ADDENDUM 1

DATE: March 29, 2024

IFB 13-24
Rockville Swim & Fitness Center Outdoor Recreation
Pool Renovations Project

No.	Description	Date
Revisions		
Project Number:	22.00036.00	
Scale:	AS SHOWN	
Drawn By:	AD, HW, BS	
Checked By:	AD	
Date:	01/08/2024	
Sheet No.	L101

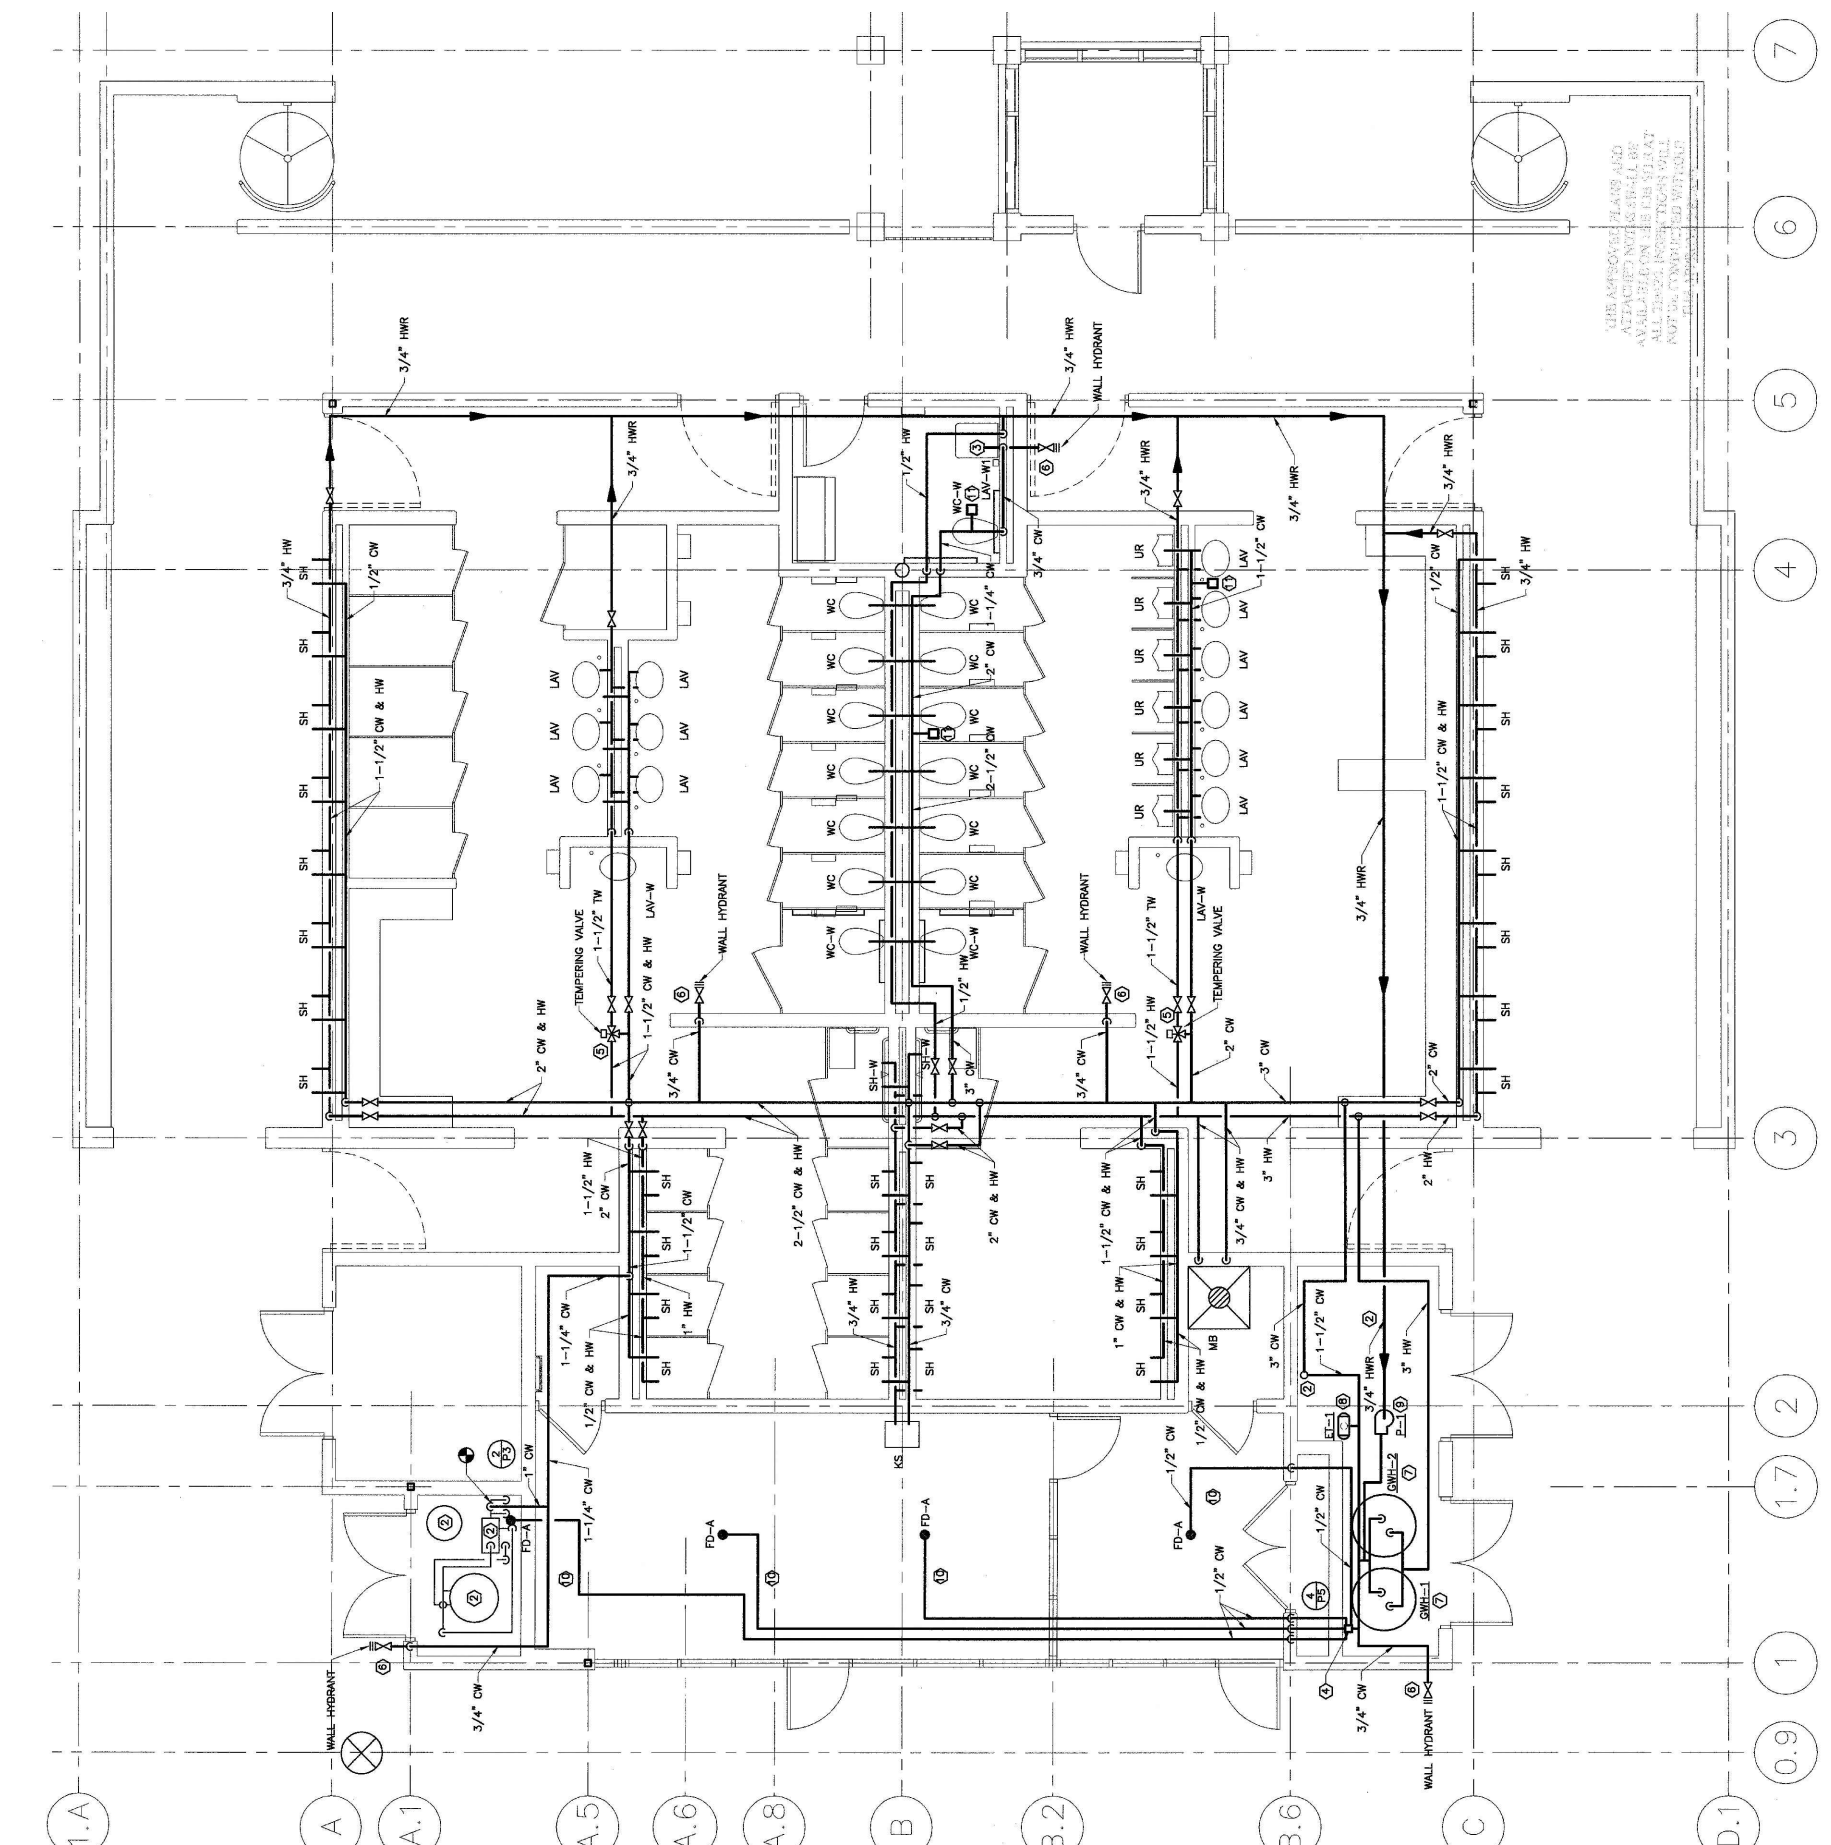
Swimming Pool Heater Add Alternate 24 on MR-1 provides BOD and scope of work to be performed, on L101 Alternate 6 this scope of work is called out to be Design Build by the GC, please advise which alternate scope the GC is to follow.

Response: The note on L101 has been revised to reference MR-1 for more information. The contractor is responsible for the scope listed on MR-1.

Sheet No. **L103**

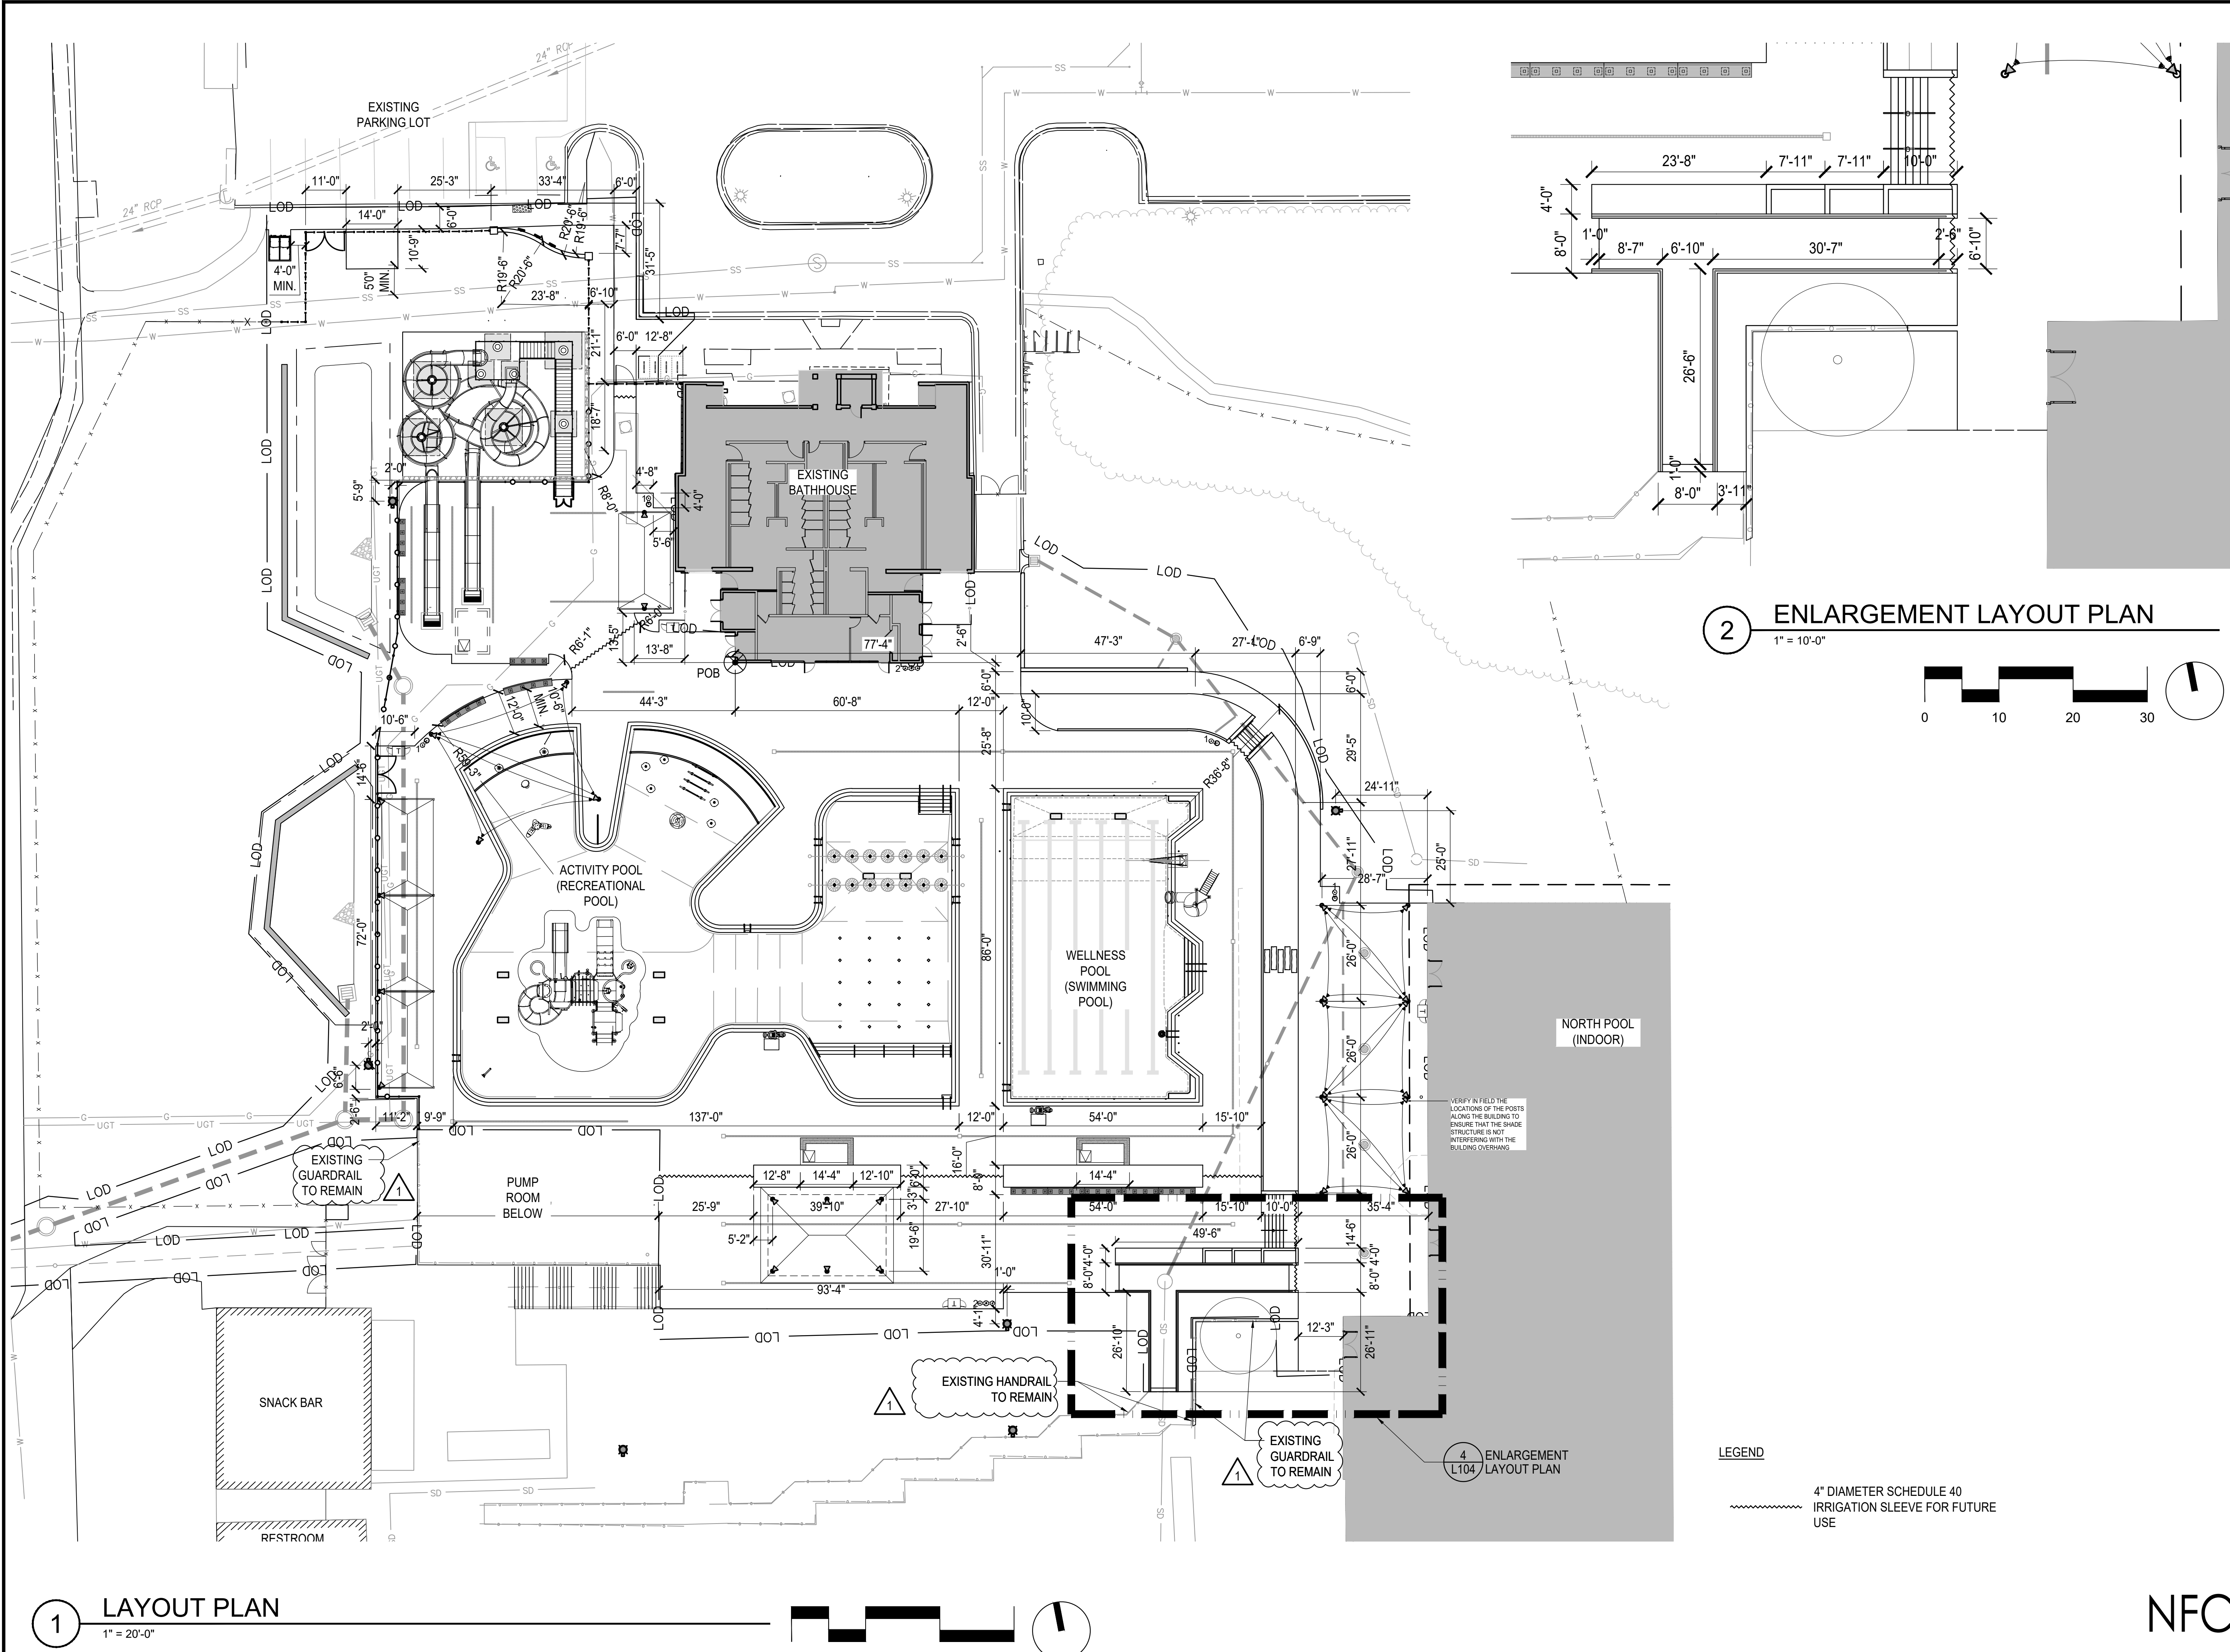
Can the existing guardrail and handrail please be added to Drawing L103, in the lower SE corner adjacent to the Existing Tree to remain. Need to understand where the existing transitions to the new. It would also be good to show Existing Handrails/Guardrails on 2/L104.

Response: Sheets L103 & L104 has been updated with labels for the existing guardrails and handrails that are to remain.

2 CANTILEVER RETAINING WALL
1/2" = 1'-0"

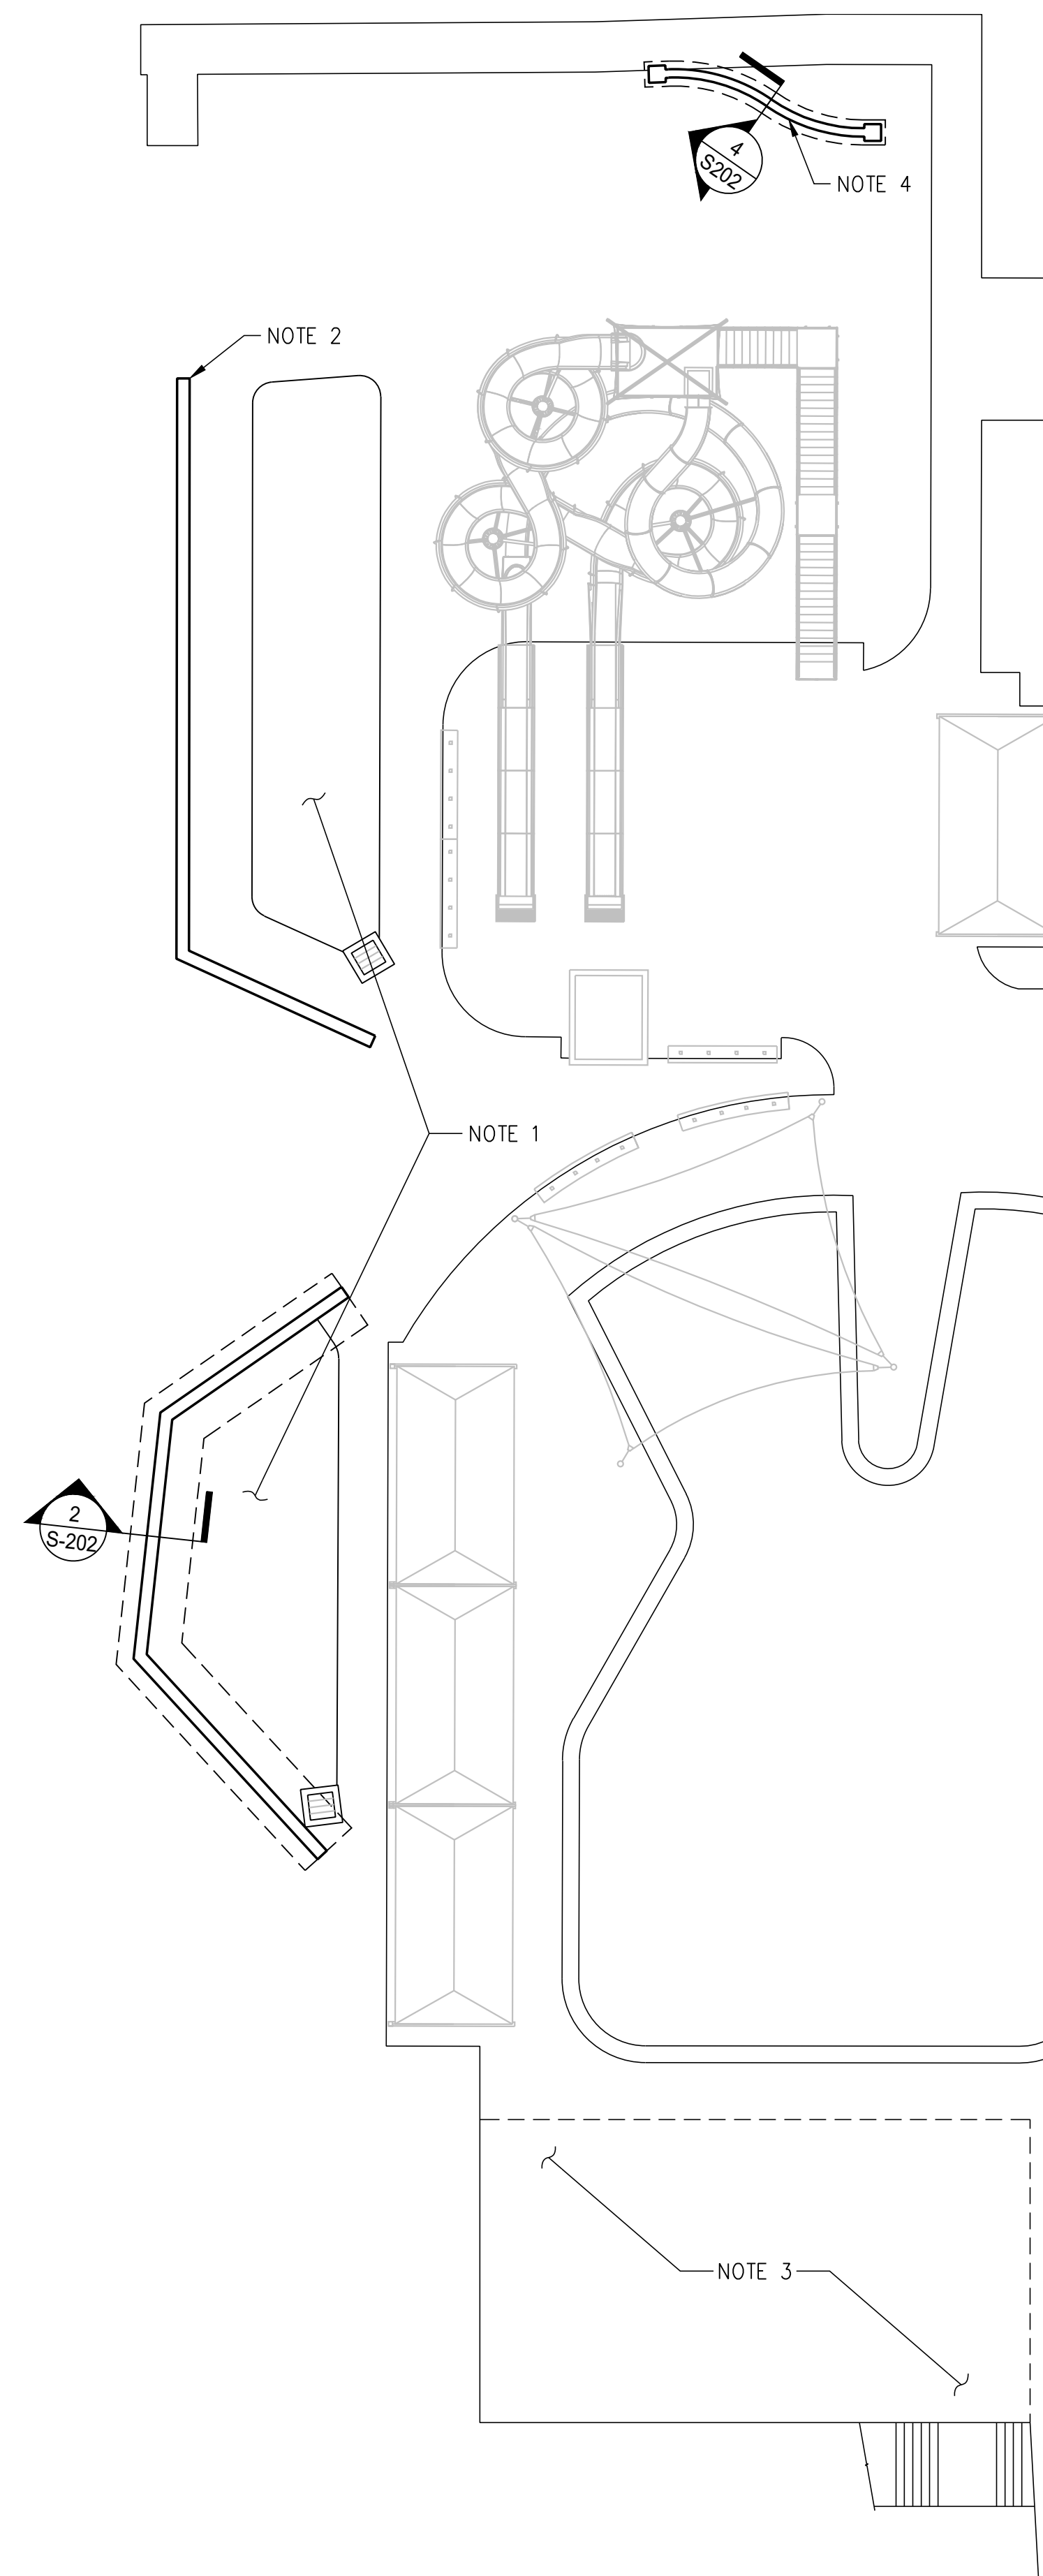
17. Drawing C-210 refers detail of retaining wall is to be provided on C-260. This sheet is not included in the bid set. Please provide this sheet.

Response: Wall A detail is shown on C-220 and Wall B detail is shown on S-202 Detail 2 Cantilever Retaining Wall.

4 FREE-STANDING SIGN SECTION
3/4" = 1'-0"

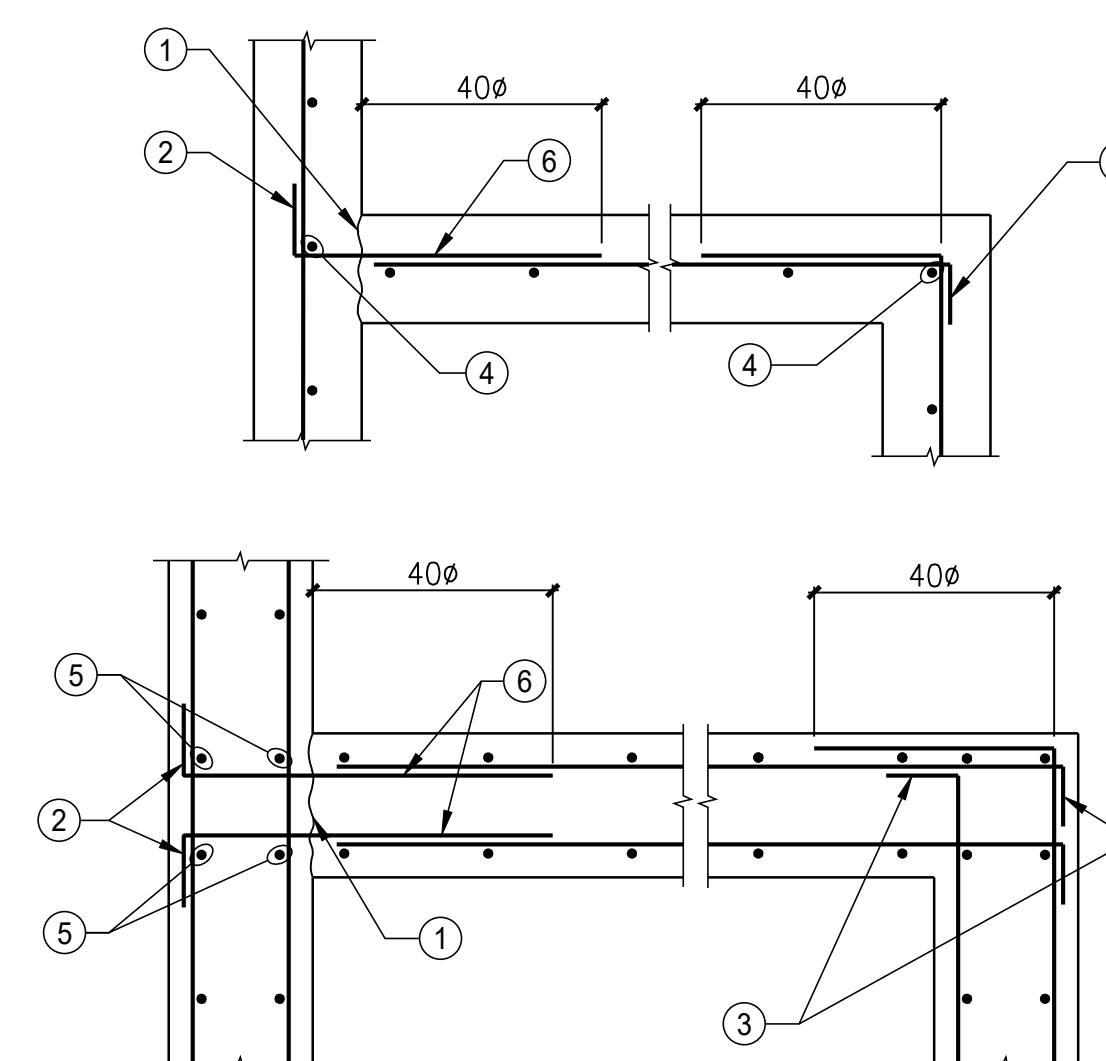
As a deduct alternate, remove the concrete entry wall, mosaic tile, logo, and lettering shown on Sheet L316 and Sheet S-202 Detail 4 (updated as part of this addendum). Replace with 7' high perimeter fencing shown on Sheet L312A Detail 3. Pricing Page has also been revised to include a line item for this deduct alternate. **Attachment A** and **Attachment B** are provided with this updated information.

22. Detail 4/L316 – refers to CIP concrete footing & CR-6 stone information to be found on Structural details. This cannot be found. Please advise on correct information?

A: See Sheet S-202 Detail 4 (updated as part of this addendum).
